## STAFF REPORT

### Site Plan & Architectural Review

**HEARING BODY:** Planning Commission  
**DATE & TIME:** **November 10, 2015 at 6:00 p.m.**  
**LOCATION:** City Council Chambers, City Hall, 500 Central Avenue, Coos Bay  
**APPLICANT:** Richard J. Ward, Richard Ward Associates,  
1312 Foster Way, Grants Pass, Oregon  
**OWNER:** Southwest Oregon IPA, Inc.,  
971 Commercial Avenue, Coos Bay, Oregon  
**LOCATION:** 281 LaClair Street, Coos Bay, Oregon  
T. 25S, R. 13W, S. 21BC, Tax Lot 100  
**SUBJECT:** **Site Plan and Architectural Review (SPAR) #187-ZON15-036 for the construction of an office and medical clinic campus**

SHEET NAME:  
PRELIMINARY SITEPLAN

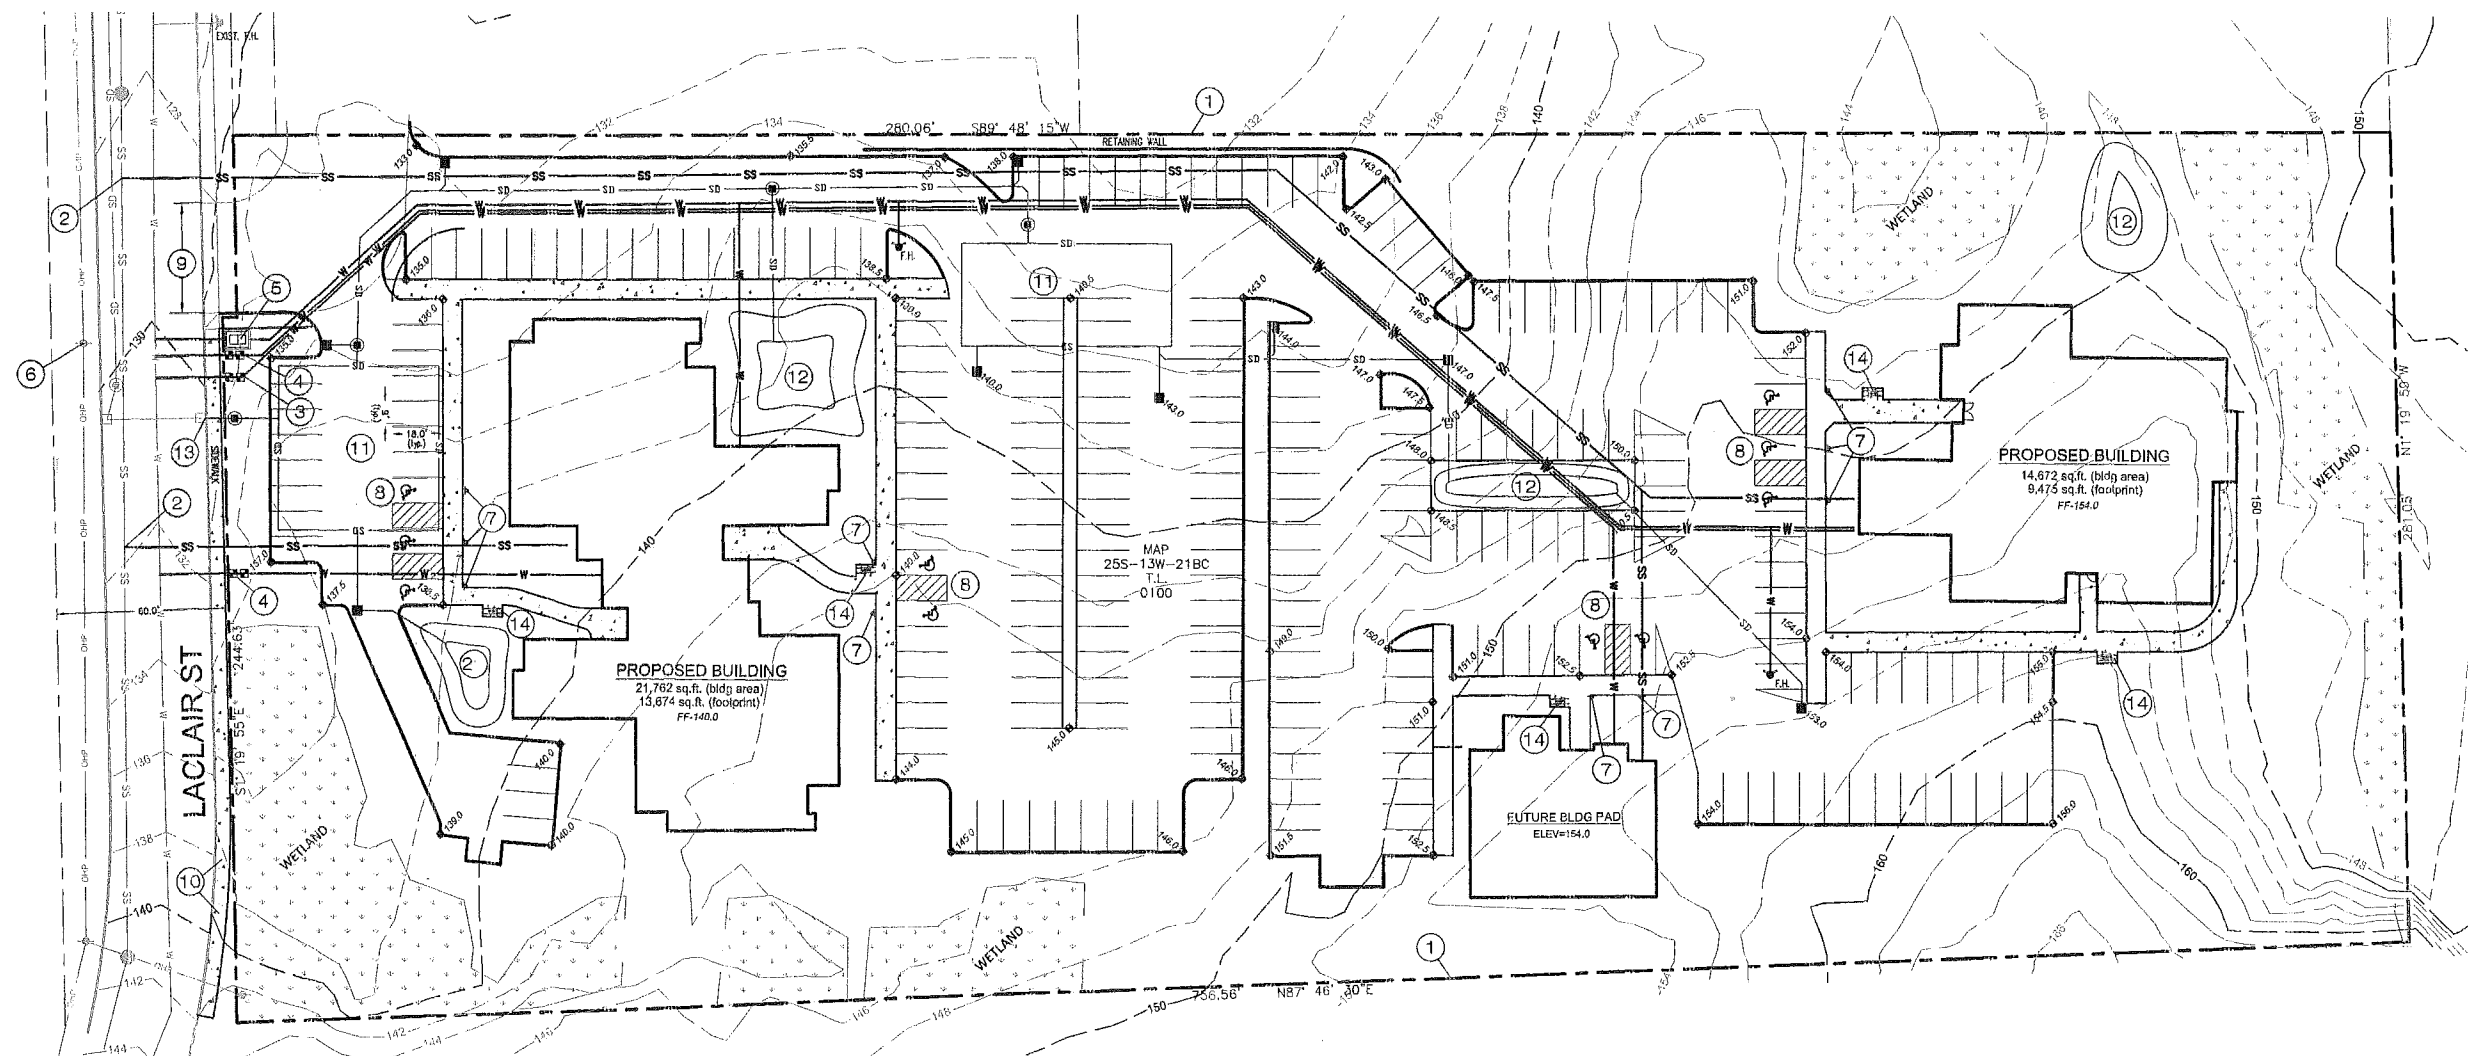
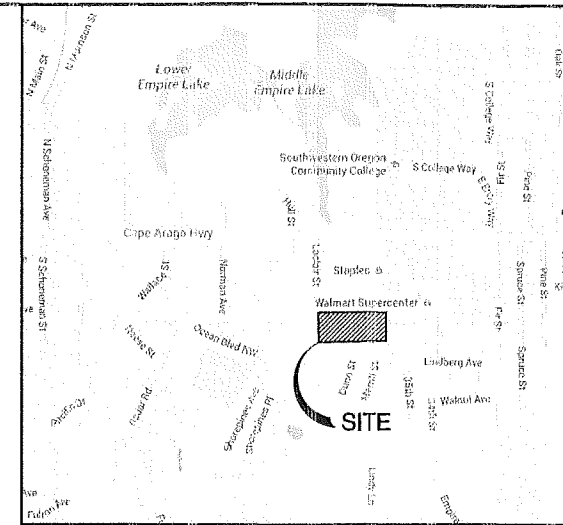
The preliminary site plan, dated 07-28-15, shows a distance of 660 linear feet from the curb of LaClair St. to the proposed hydrant at the SW corner of structure #2. Based on that information, OFC Appendix D, Table D103.4 indicates that the required width of the access road be no less than 26 feet exclusive of shoulders and the slope shall not exceed 10 percent in grade. Access width shall be maintained throughout parking layout to allow fire department apparatus to turn around without impedence. The provided site plan shows a reasonable ability for fire apparatus to turn around within the parking layout and therefore, as proposed, no additional turnaround is required.

- 4c. The submitted site plan completely ignores an internal pedestrian system connecting the two buildings. Expecting users of the buildings to walk from one building to another through parking lots and stepping over or through landscaped areas creates a substantial concern for pedestrian safety, especially since it is stated in the narrative that some users come to the campus through alternative transportation means other than private automobile. It is incumbent on the applicant to provide a revised site plan addressing this situation in order to fully support this criterion.

6. **Existing storm drainage along LaClair Street is not correctly delineated on the submitted site plan as a part of this application. Prior to approval of any applicable building permits, a revised site plan shall be updated and accepted by the City's Public Works Director to adequately reflect existing conditions.**

7. **The northeast retention pond on the site plan does not have an outfall pipe. However, per a memo received by City staff on October 5, 2015 by the RC Group, two outfall pipes shall be installed that direct flows to one of the two wetland areas. It shall be the responsibility of the applicant to ensure that all applicable resource agency permits and approvals are obtained prior to commencement of work. Outfalls shall be protected with rock/energy dissipaters. Flows leaving these two wetland areas cannot adversely impact existing OCCA development to the north.**

20. A revised site plan shall provide details on the location and width of an internal pedestrian system, which also connects to the public sidewalk along LaClair Street, to provide safe passage within the campus between the clinic and office buildings. A note shall also be added regarding delivery truck parking for loading and unloading.

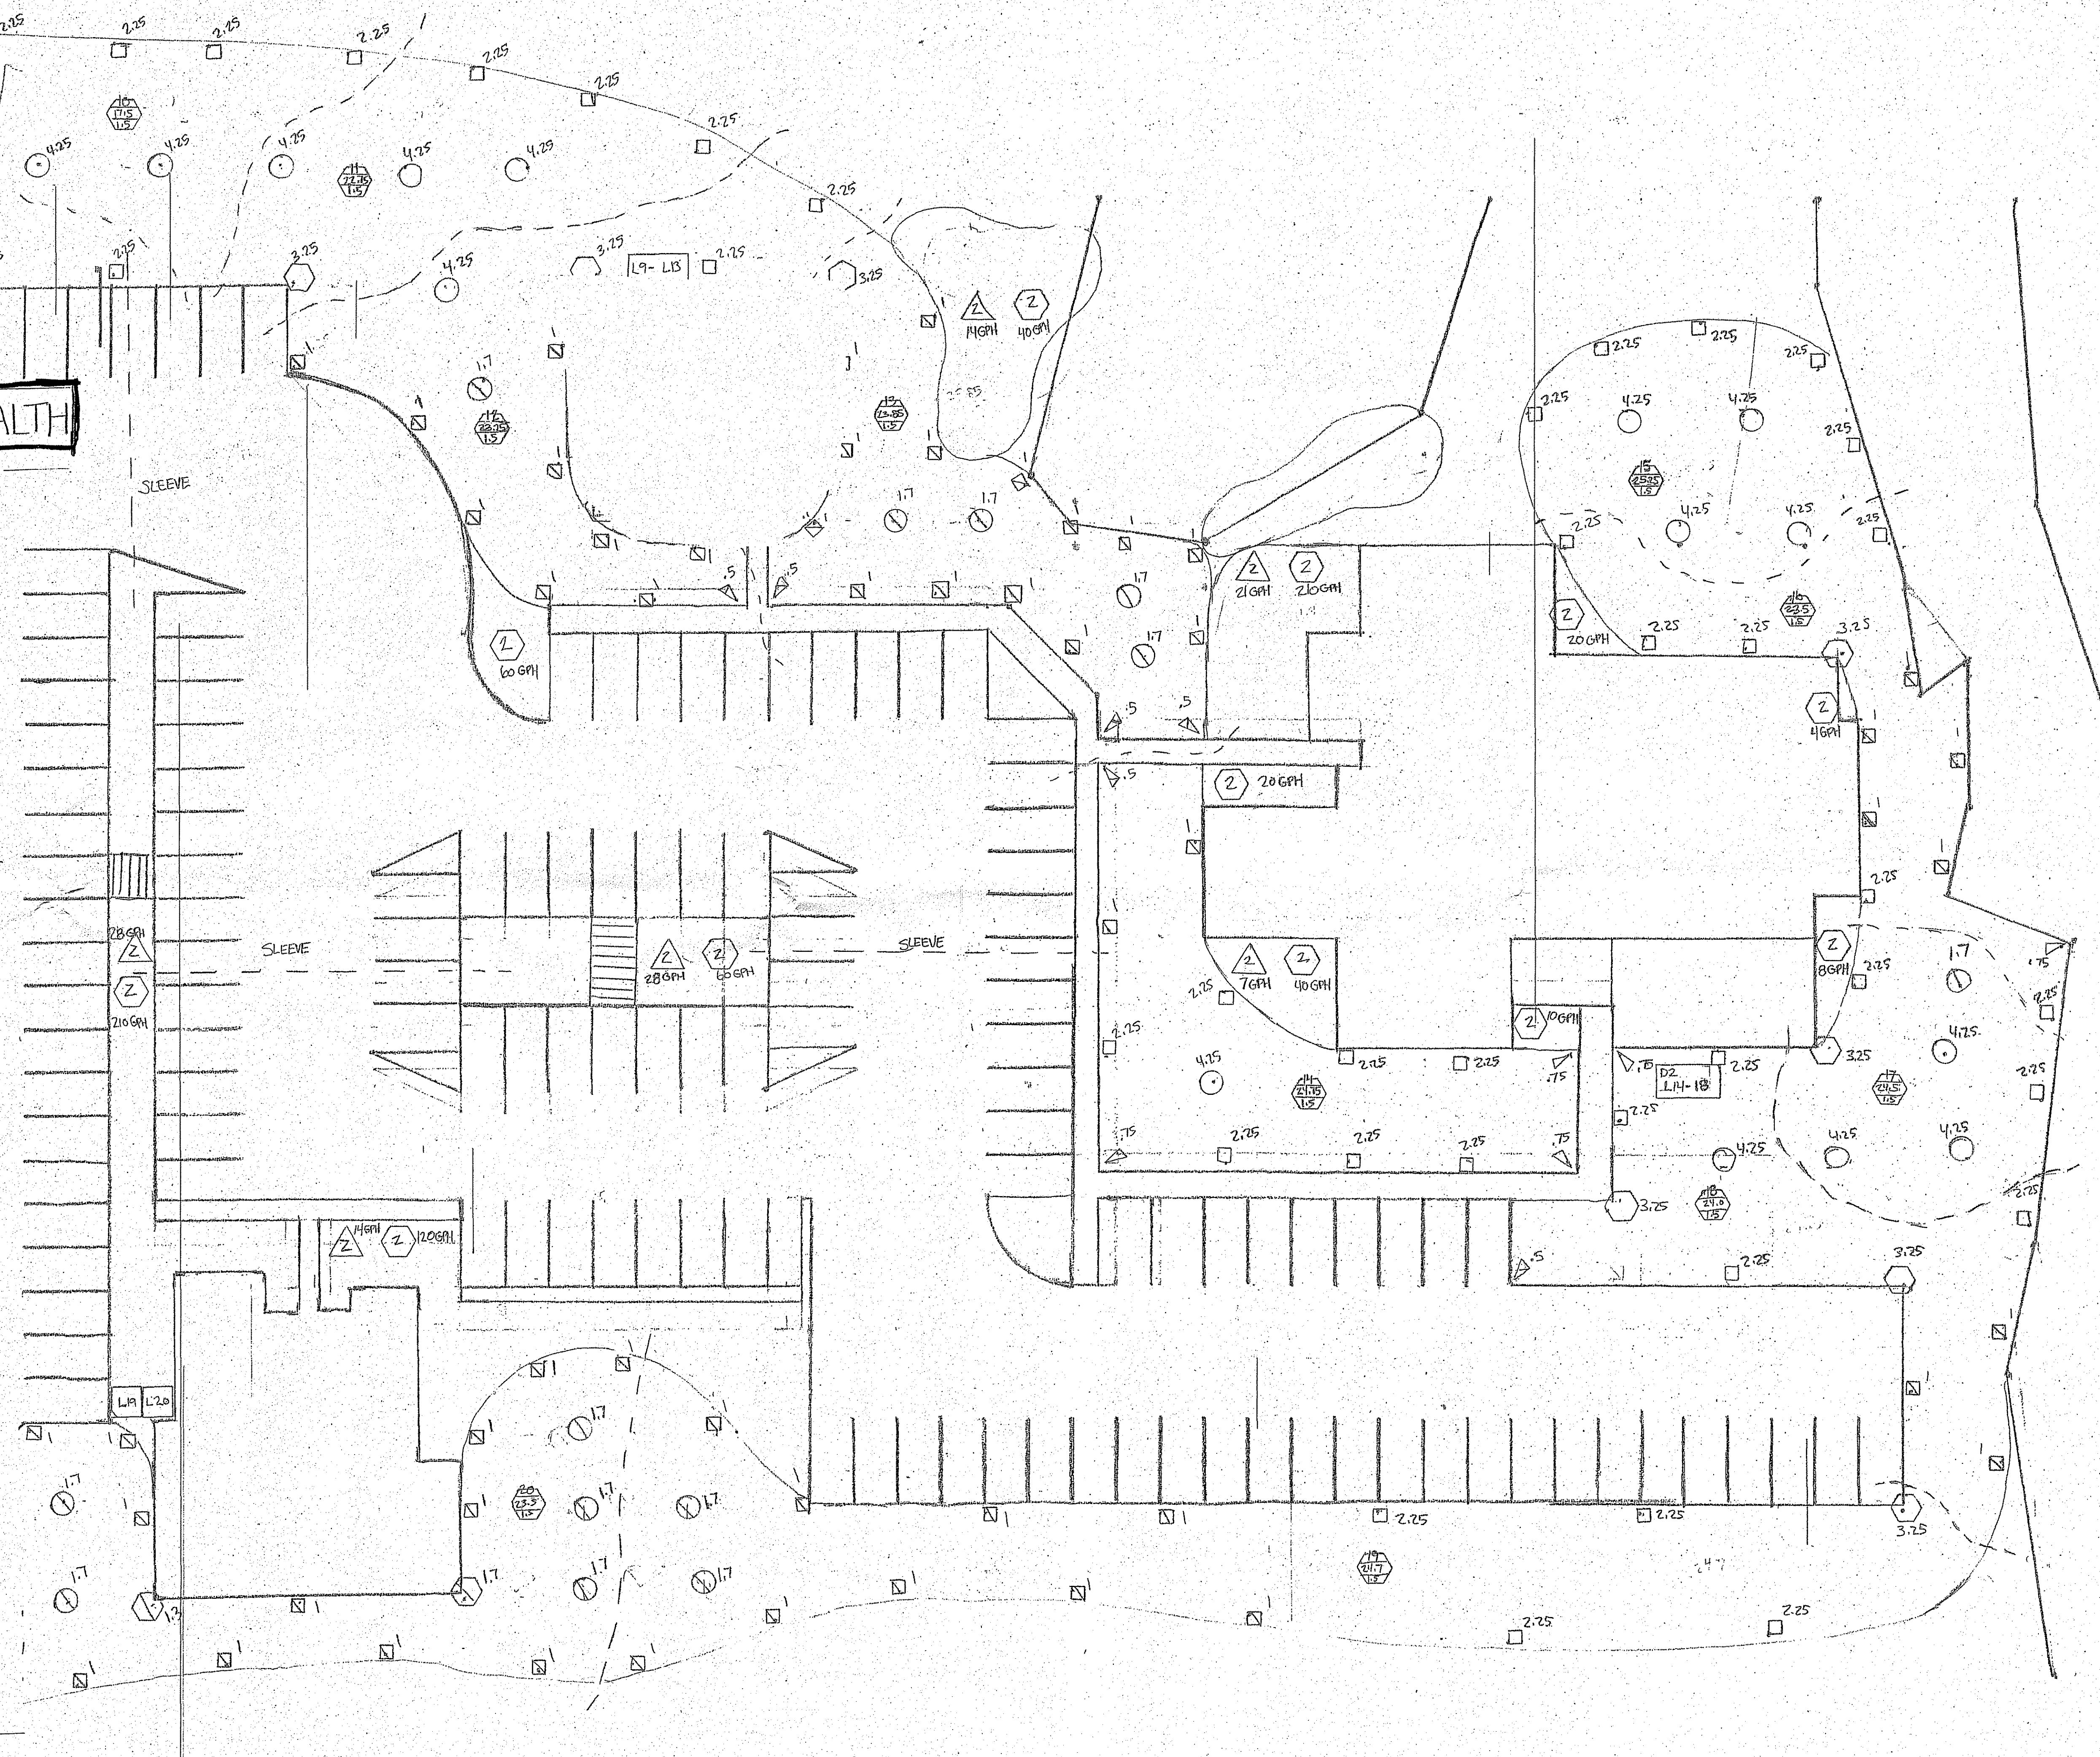
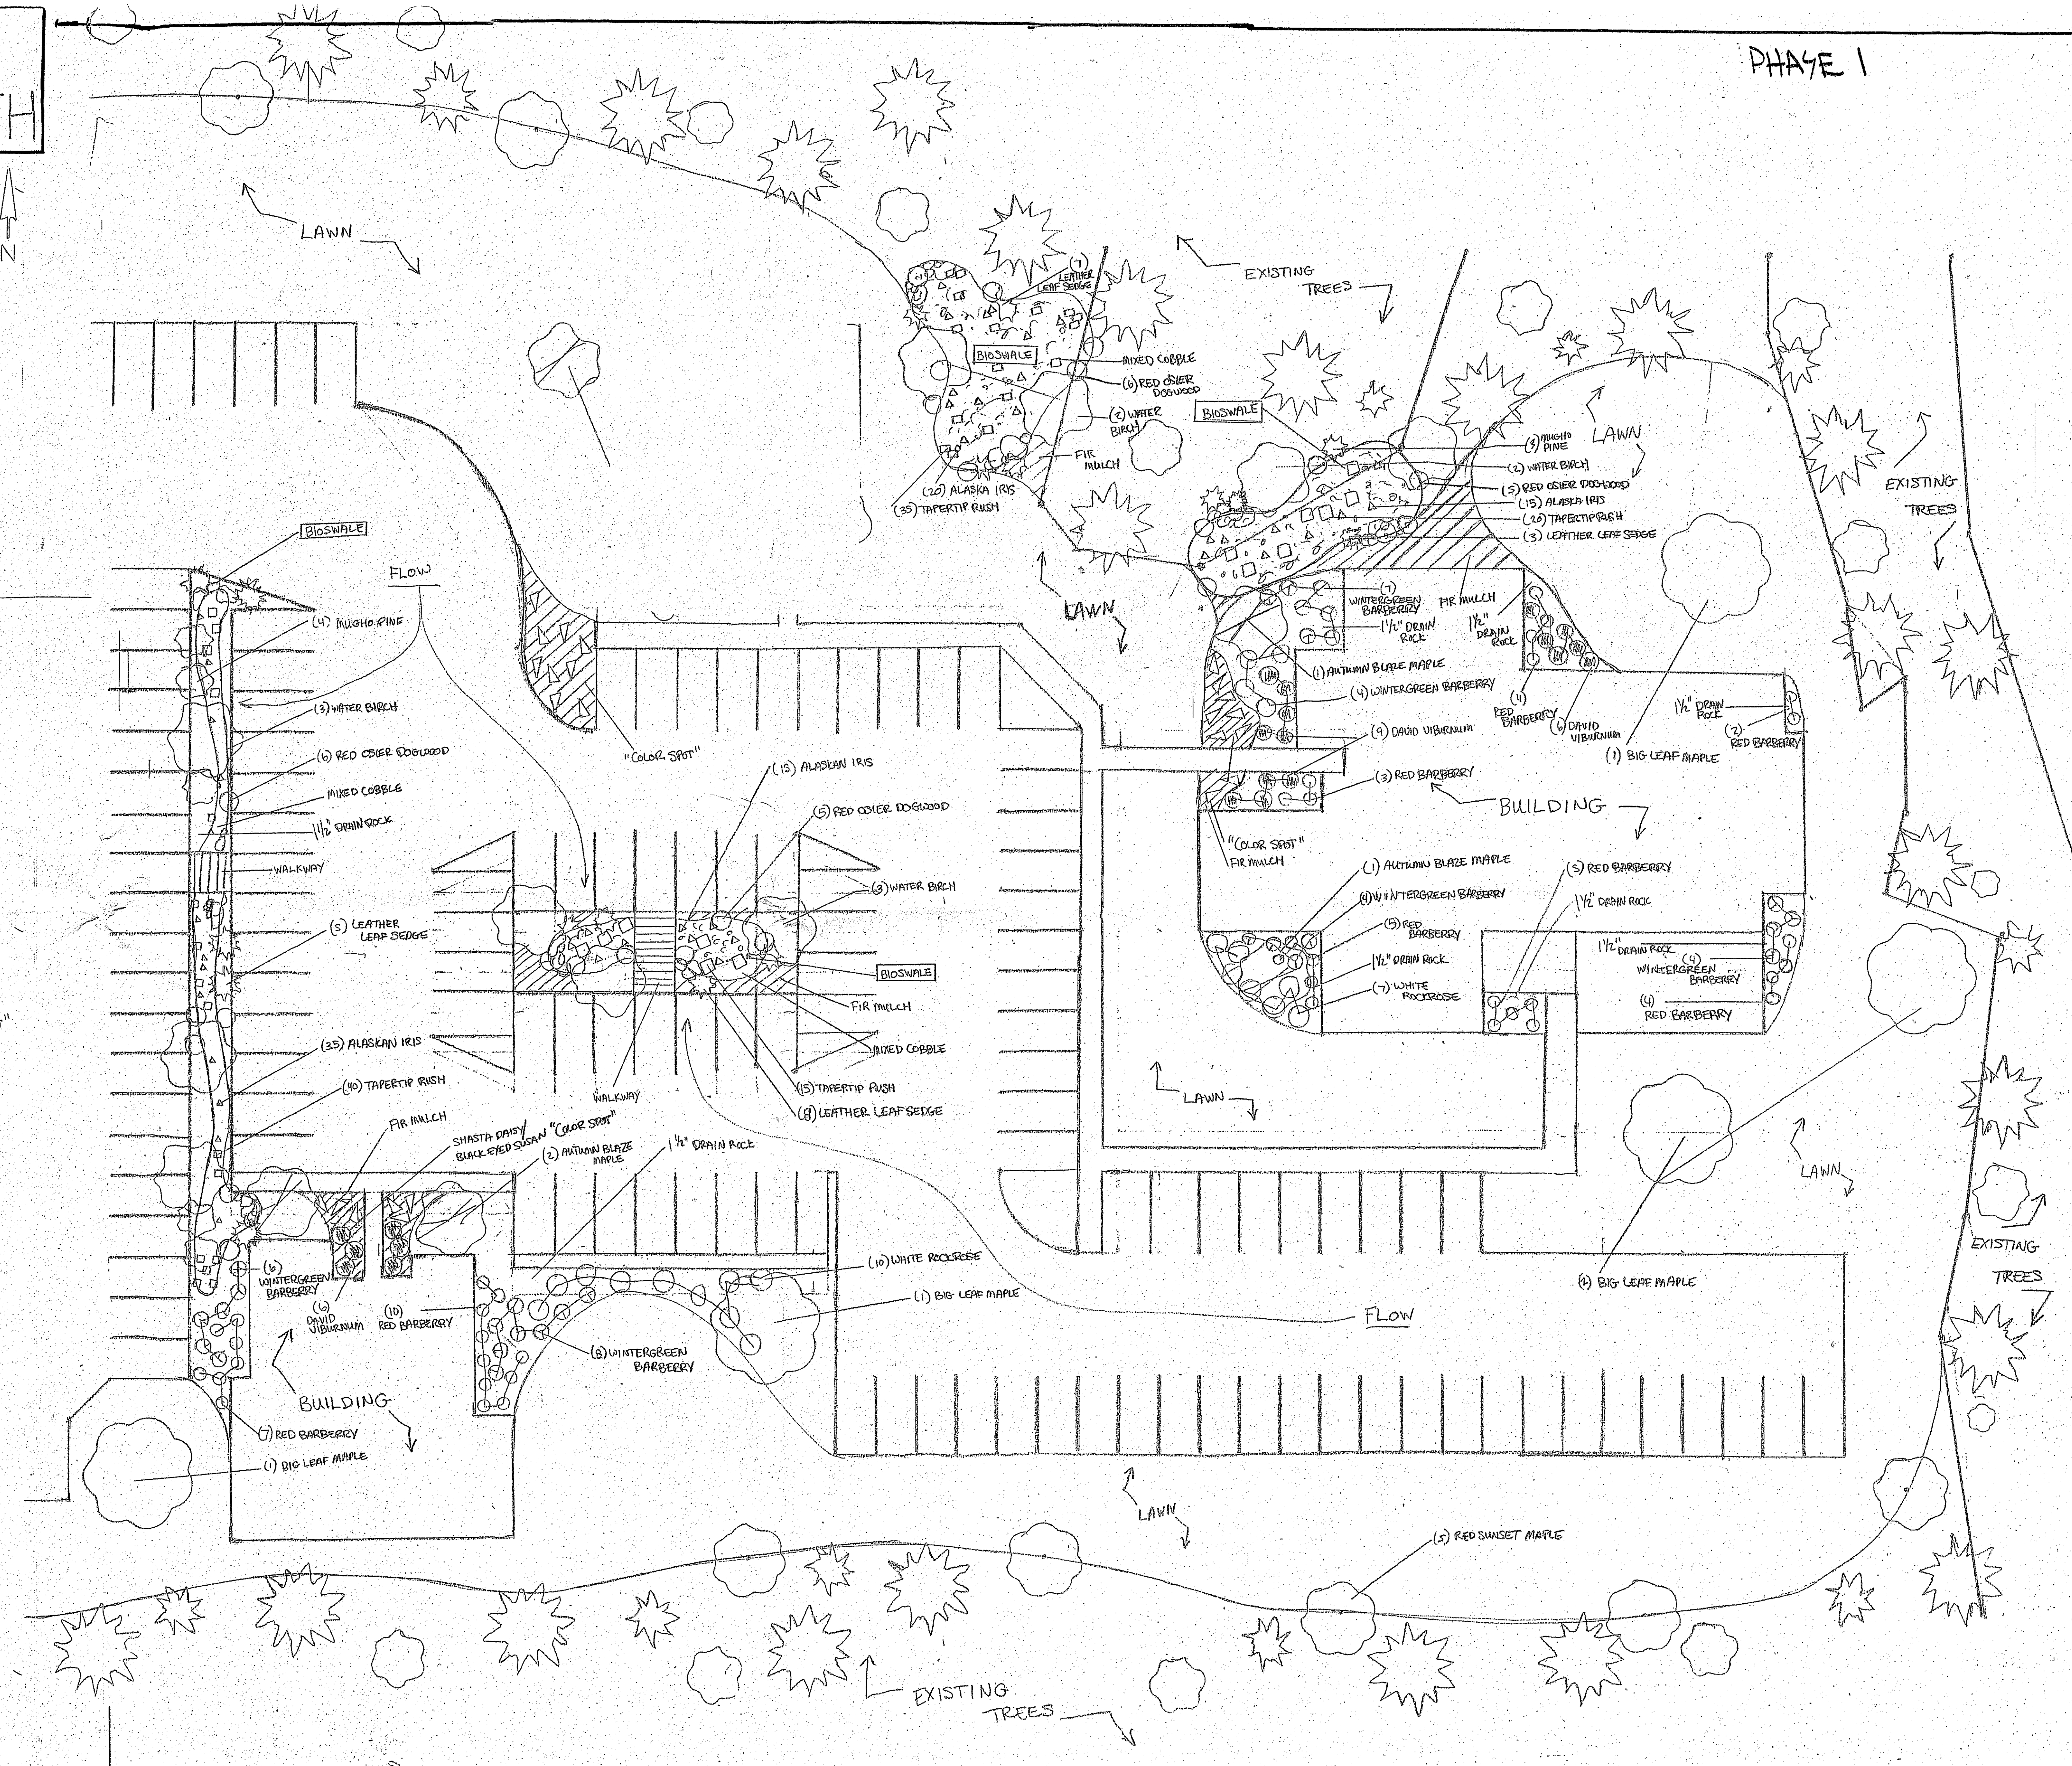
Details for drainage from proposed buildings, such as location of down spouts, cross sections for drainage swales, and how the drainage between the swales would interact are all missing from the landscaping plan. A rain garden from roof drainage and into bio-swales would be both a functional, practical and cost-saving means of using drainage to support a healthy landscaping scheme. A final landscape plan shall be submitted that depicts these items to ensure a positive interaction between landscaping and site drainage when the property is fully developed.

The plant list and landscape plan does provide a healthy mix of trees, groundcover, and hardscape elements. Maples, barberry, birch, and Mugo Pine trees are intermixed with groundcover, sedge, mulch, and rocks and boulders. However, the site is the remnant of an upland forest community so the preservation of mature firs and cedars should remain a strong element of the site's development.
